Edwin I. Hatch Nuclear Plant
Additional Information Related to the Staff's Review of the License
Renewal Environmental Report (TAC Nos. MA8096 and MA8098)

Enclosure: SNC Response to RAIs 19 and 20

**OFFICE OF NUCLEAR REACTOR REGULATION REQUEST FOR ADDITIONAL
INFORMATION RELATED TO THE STAFF'S REVIEW OF THE ENVIRONMENTAL
REPORT RELATED TO LICENSE RENEWAL FOR THE EDWIN I. HATCH
NUCLEAR PLANT, UNITS 1 AND 2 (TAC NOS. MA8096 AND MA8098)**

FIGURE 2

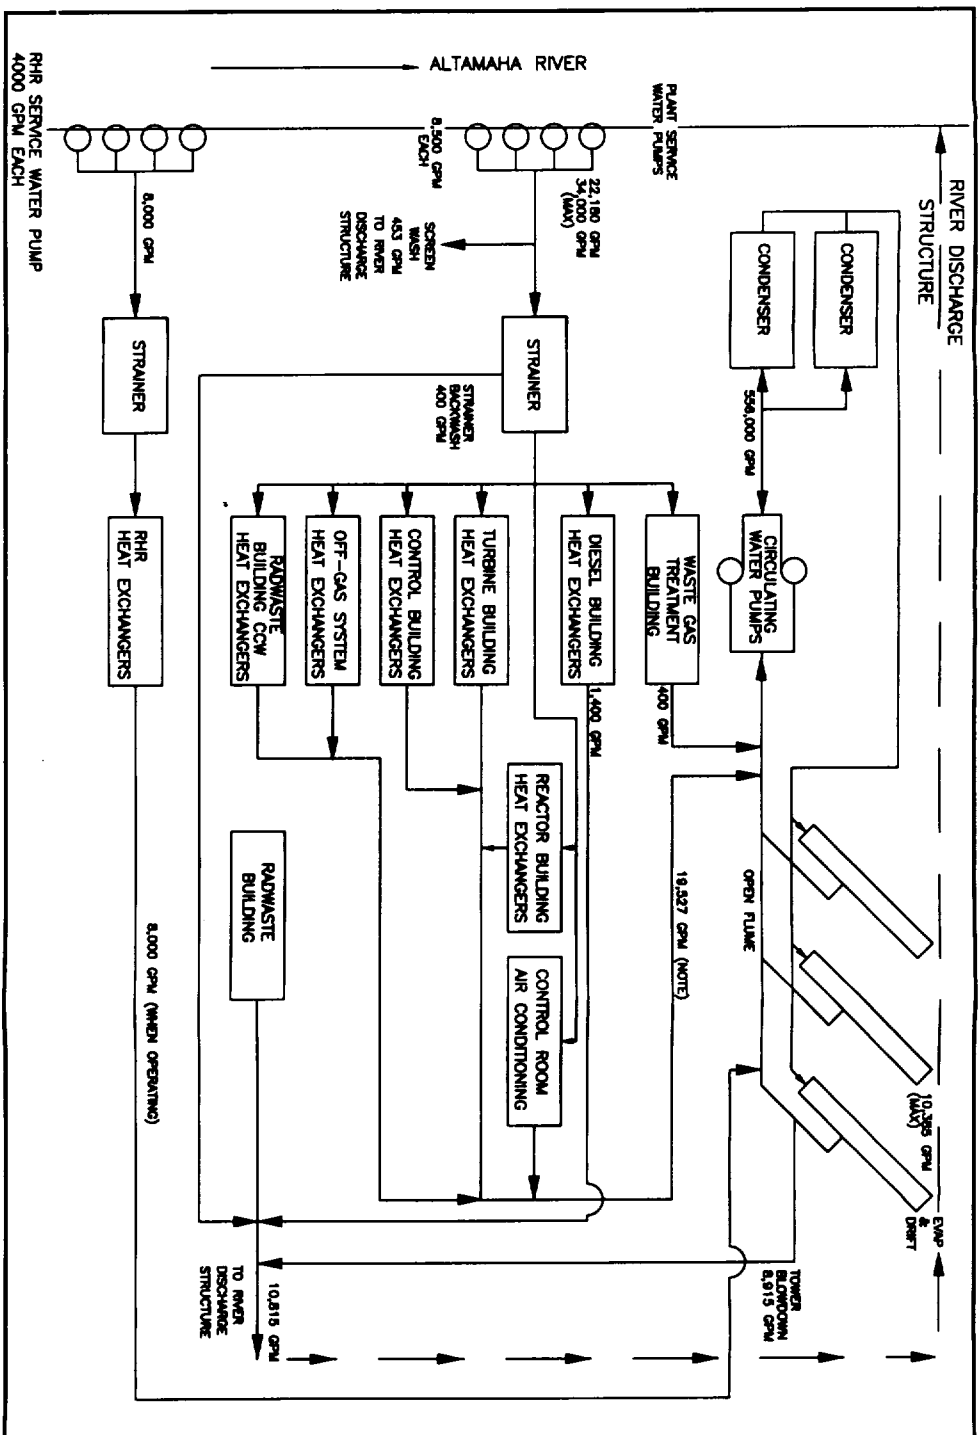
- 19. The values used in the water system flow schematic (page C-104 of ER) are outdated. Provide a plant water flow diagram with current flow values.**
1. The following revised Figure 2 (page C-104 of ER) reflects the current flow values. The flows are based on the normal mode of operation of the PSW system and are subject to variation depending on the number of components in service.

NOTE: FLOW LEVEL MAY BE CONTROLLED BY ADJUSTING THE TOWER BLOW DOWN AS PER PLANT PROCEDURE. ALSO, THE CIRCULATING WATER MAKEUP DEMAND IS LIKELY TO BE HIGHER THAN INDICATED BY THE DIAGRAM DUE TO THE USE OF ADDITIONAL 'HELPER' TOWER.
